City of Pittsburgh Contract and Scope of Work for Fern Hollow Bridge Rehabilitation

**RE: Forbes Avenue Bridge over Fern Hollow
Structural Engineering Services
Open-Ended Contract No. 05301
BTE Project No. 07300-5
Work Order No. 5**

**Subject: Structural Engineering Services
Open-Ended Contract No. 05301
Work Order No. 5 (Forbes Avenue Bridge – Frick Park) - Repairs**

CITY OF PITTSBURGH
FORBES AVENUE BRIDGE
WORK ORDER NO. 5

B. T. E. PROJECT NO. 07300-5		
CITY OF PITTSBURGH DEPARTMENT OF PUBLIC WORKS BUREAU OF TRANSPORTATION AND ENGINEERING FORBES AVENUE BRIDGE OVER FERN HOLLOW AND NINE MILE CREEK, FRICK PARK		
BRIDGE REHABILITATION FRAME LEGS AND BRACING RETROFIT

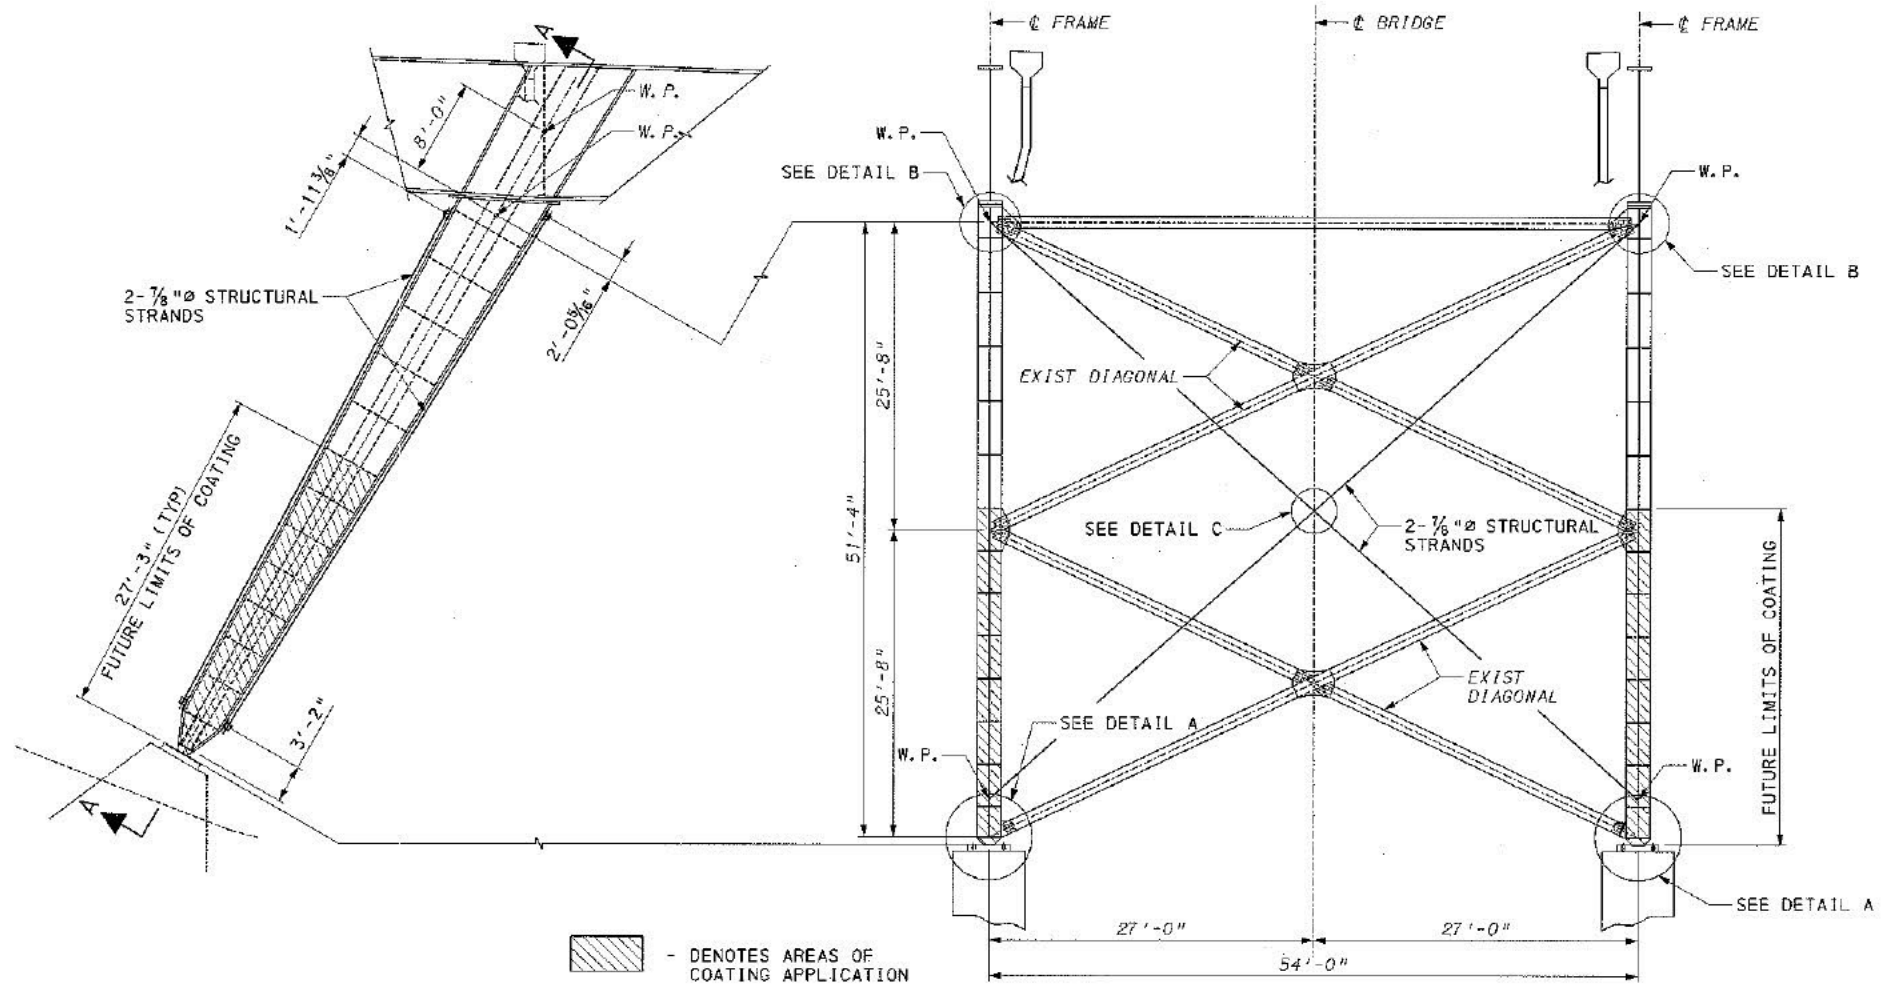
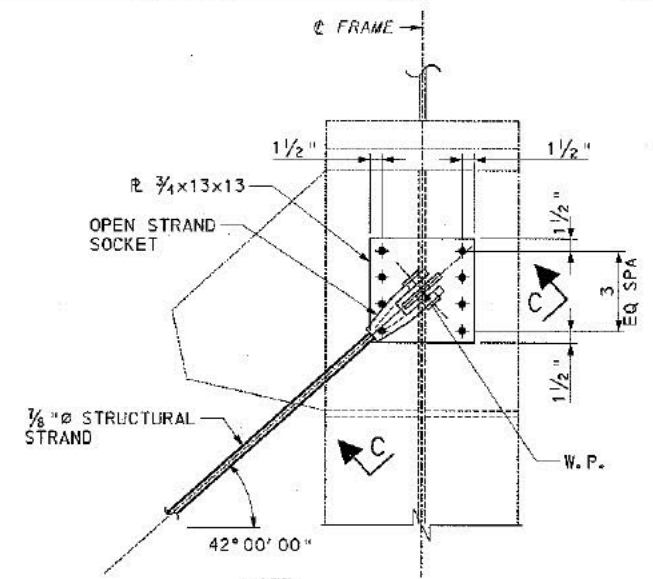
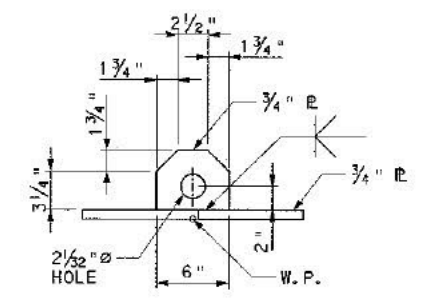
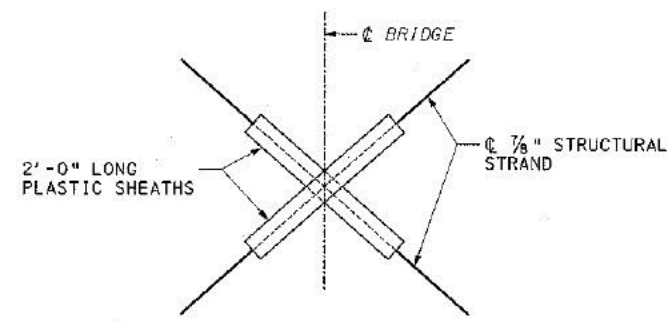
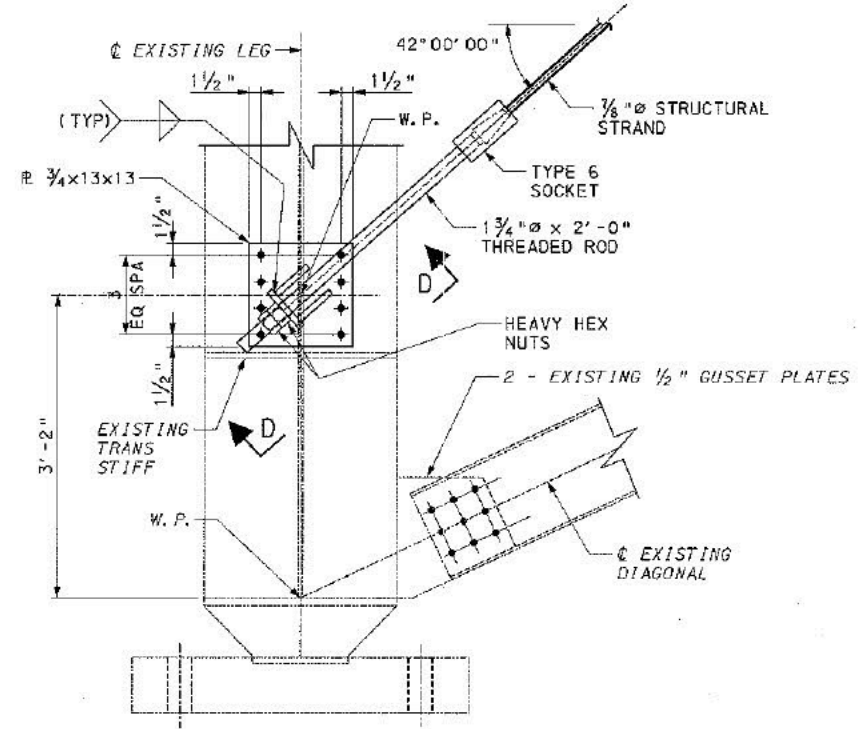
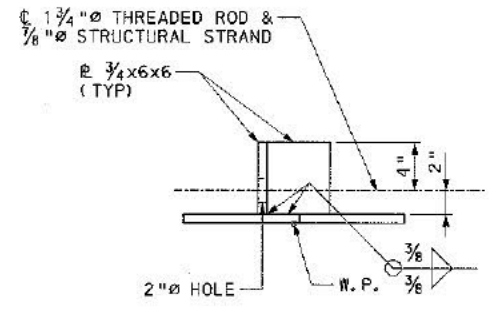
- 8) Correct me if I'm wrong: once the lower bracing lets go, the new cables can resist the entire amount of applied lateral load (up to the 50 P.S.F. design load). When new, the lateral stiffness from the upper bracing was probably pretty equal to the lateral stiffness from the lower bracing, thus causing little, if any, minor axis bending in the frame legs at the mid-height gusset plates. Intuitively I imagine that

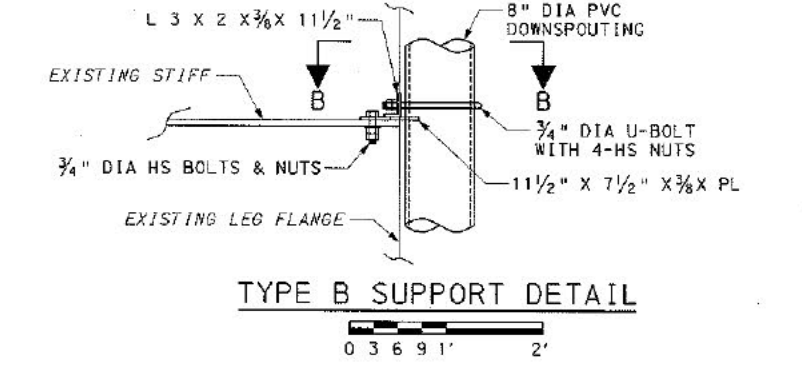
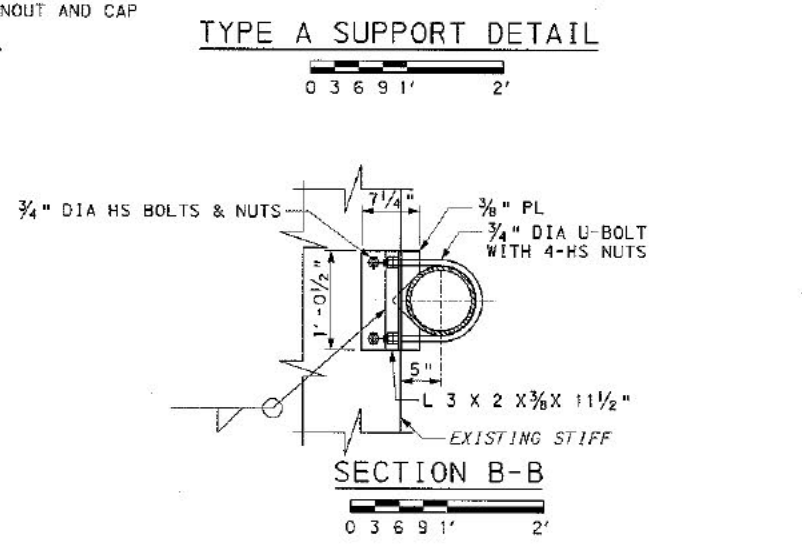
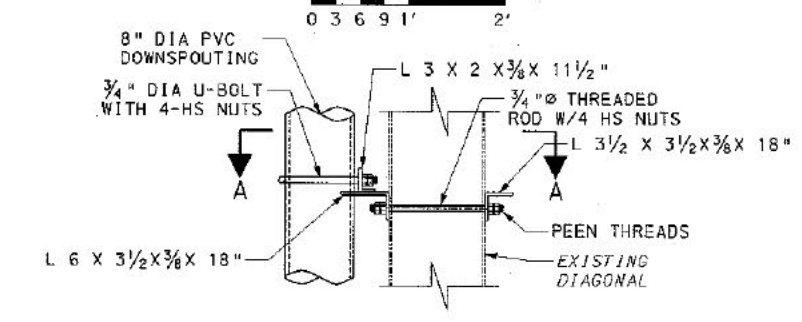
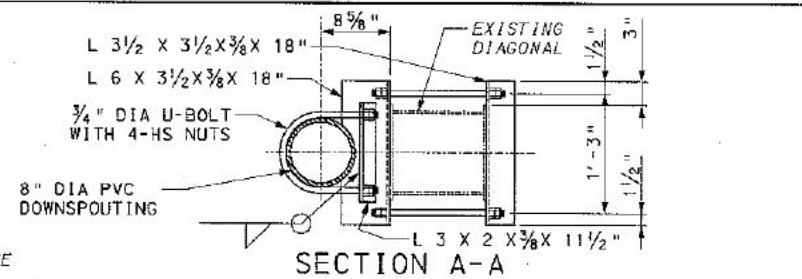
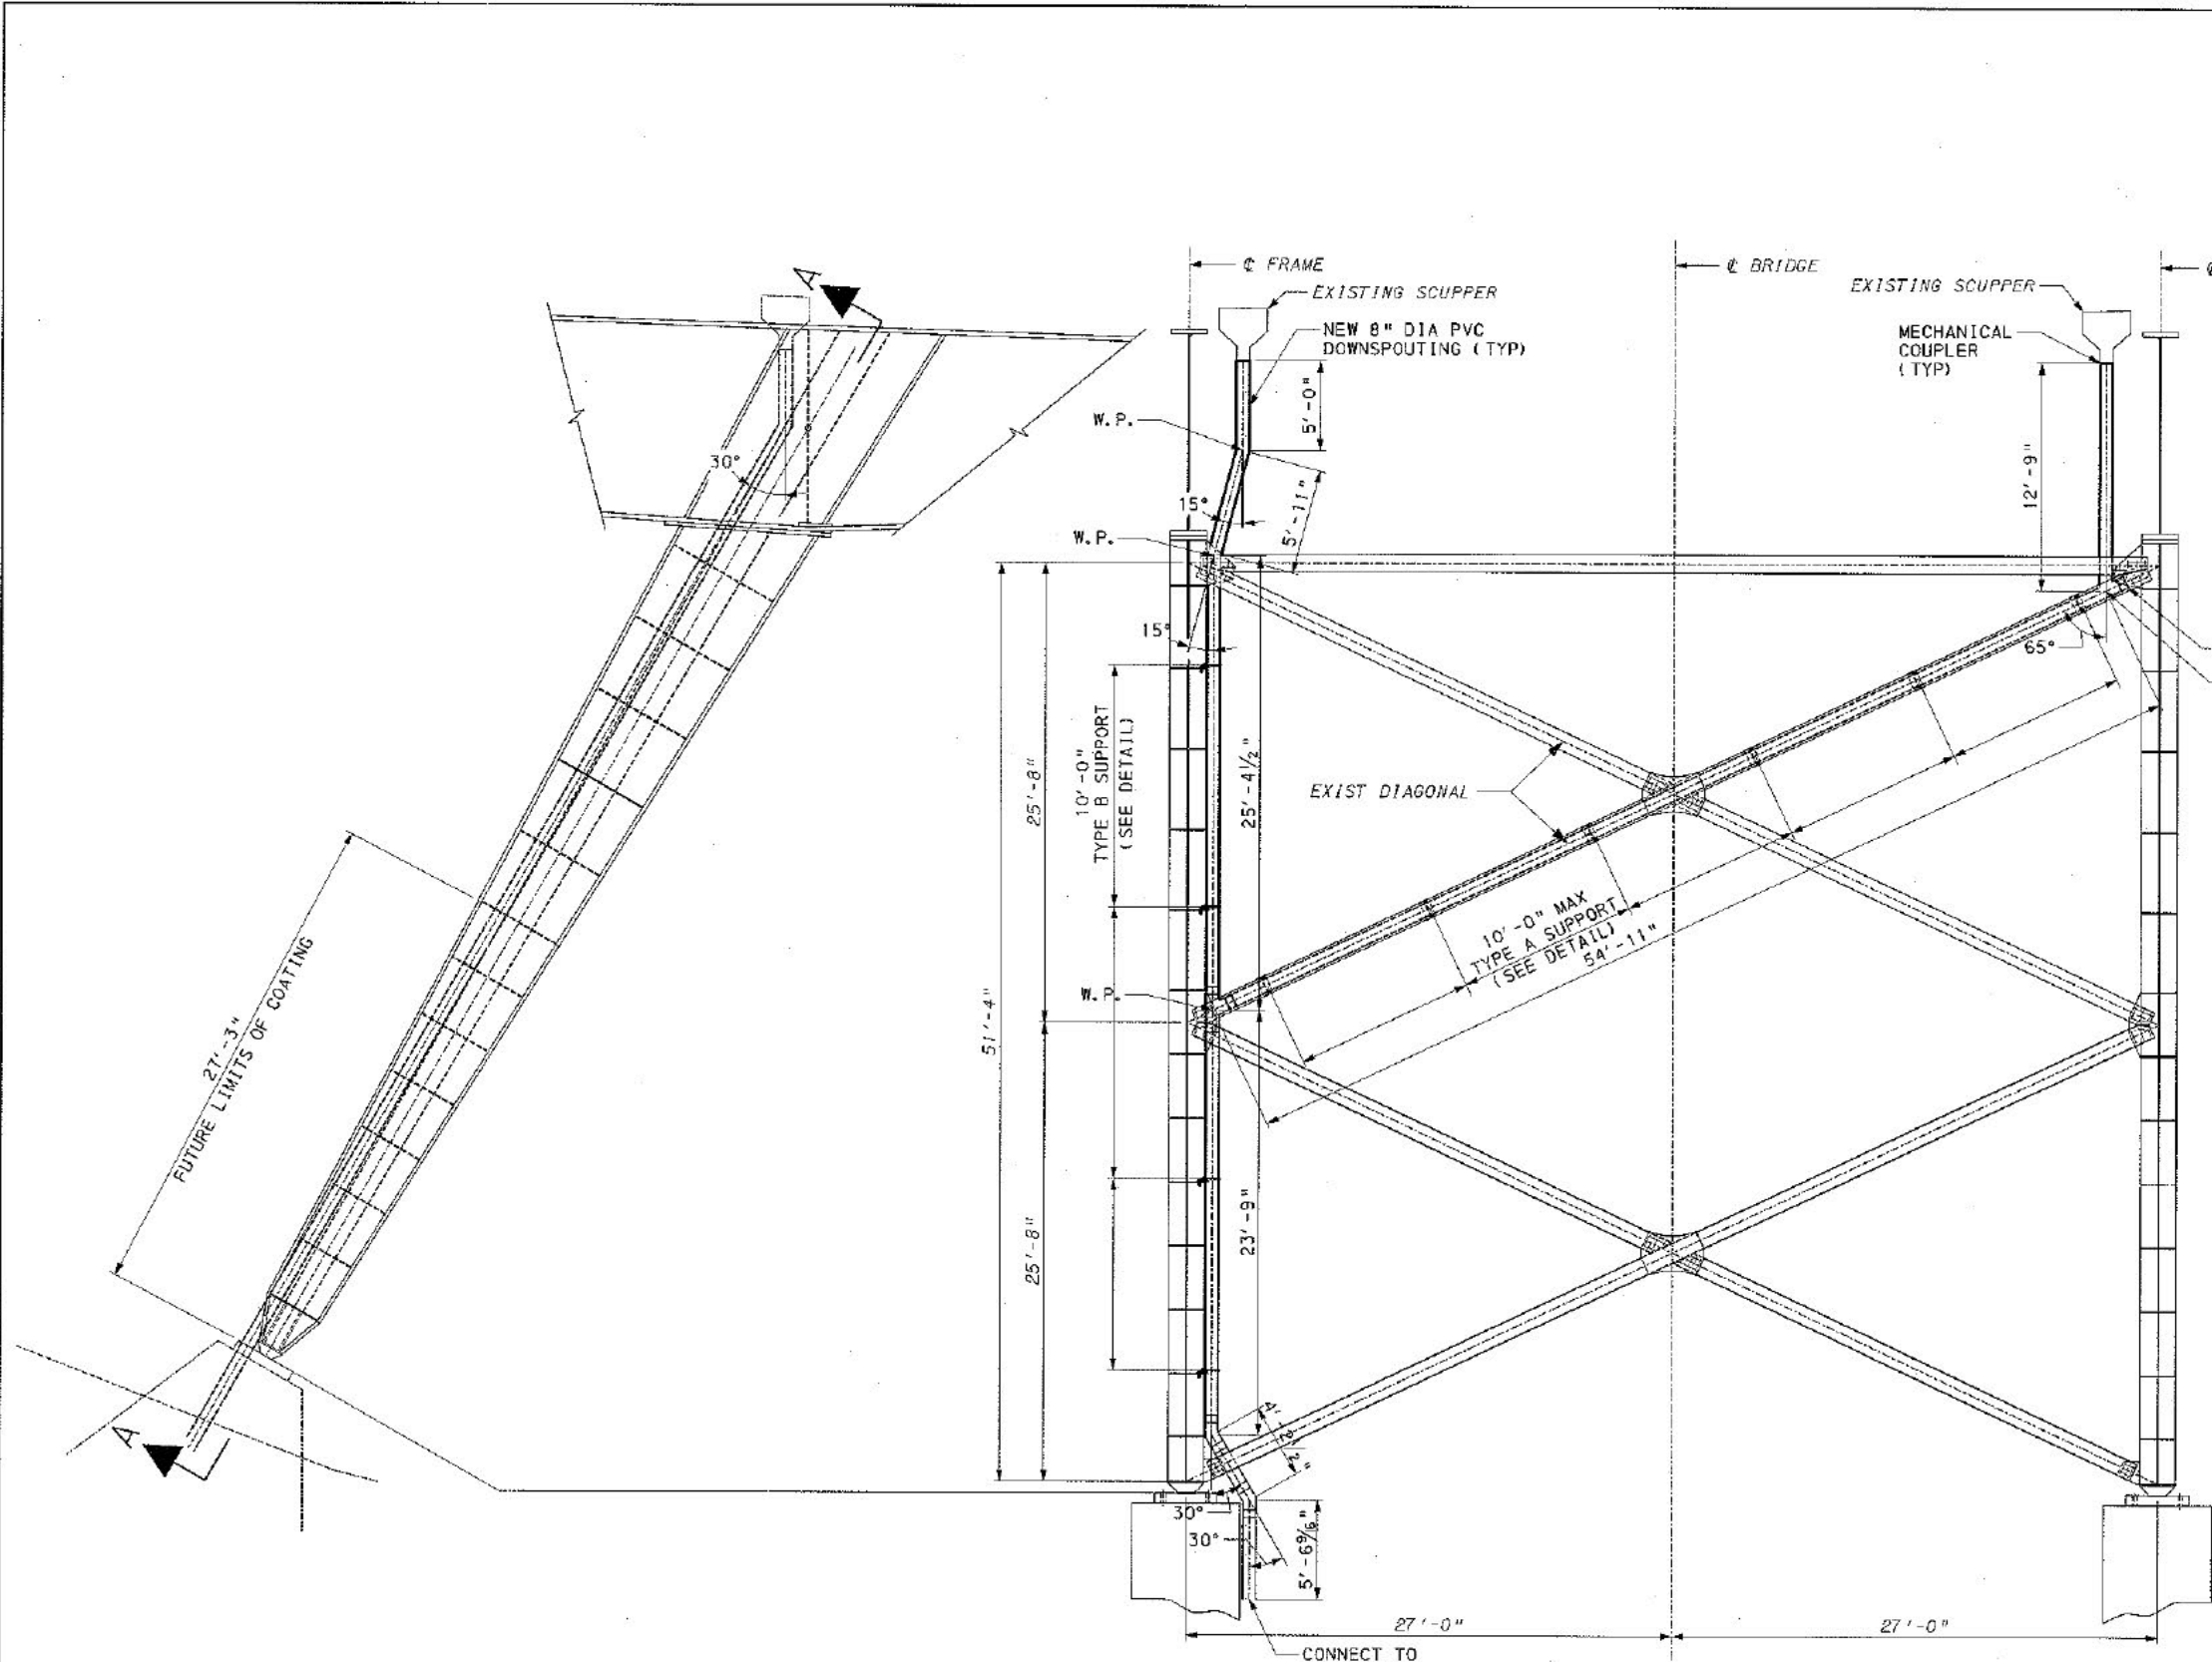
- 4) The entire length of downspout is being replaced; line weight on sheet 5 of 5 seems somewhat inconsistent. *The line weights will be improved for clarity.*

- 5) Is it practical to keep the downspouts away from the leg enough that if (or when) the pipe/joints split open, that the winter runoff will not saturate the legs? *It is not intended for the downspouts to split. Relocating the downspouting/scuppers or modifying the downspouting attachments to the legs is impractical. In discussing this question, however, the possibility of free drop scuppers arose. Although most frequently utilized over waterways, they have been used at other locations, often with conical diffusers attached to break up the flow of the water. If used, downspouting from the scuppers would extend far enough below the structural steel so falling water would not hit the legs. This would also improve the clearance between the proposed drainage system and the cables.*
